Revised Final Plan
Attachment 7.5

**Response to Draft
Decision on Opex**

October 2020

This attachment sets out our response to the ERA's Draft Decision on operating expenditure (opex) for the DBNGP over the 2021 to 2025 Access Arrangement period (AA5). In particular we are responding to:

Figure 1.1: Productivity growth for the EGWWS sector

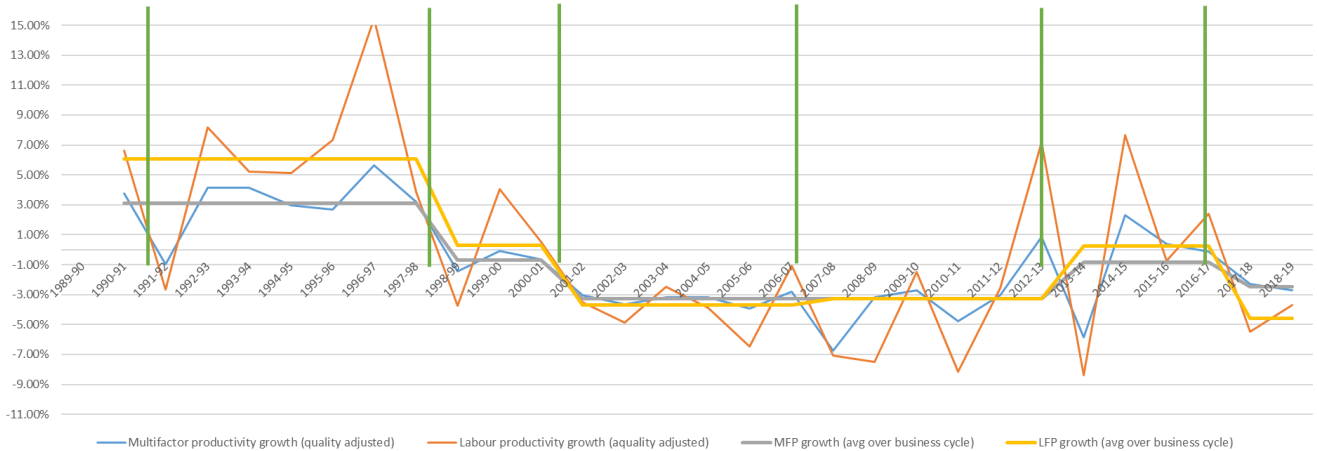
The gas distribution results presented in the AER report dated from 2016 and earlier. More recent evidence suggests that these figures are now out of date and that productivity growth rates in the gas sector have cycled downwards. This is shown in Figure 1.1 below for the Electricity Gas, Water and Wastewater (EGWWS) sector, where the green lines indicate the business cycles the ABS has determined for this sector.

The AER has noted that it is desirable to consider whole business cycles, including to avoid year-on-year volatility.⁴¹ The data show a drop in average labour productivity growth from 0.2% per annum in the last cycle to -4.6% per annum in the current cycle (with similar drops in multifactor productivity growth). This suggests the upward trend which the AER observed starting in 2012 that caused it to shift in its 2019 report from using 0% as the productivity adjustment factor to using 0.5% has now run its course and that future growth is now lower; just as it was in previous cycles before 2012.⁴²
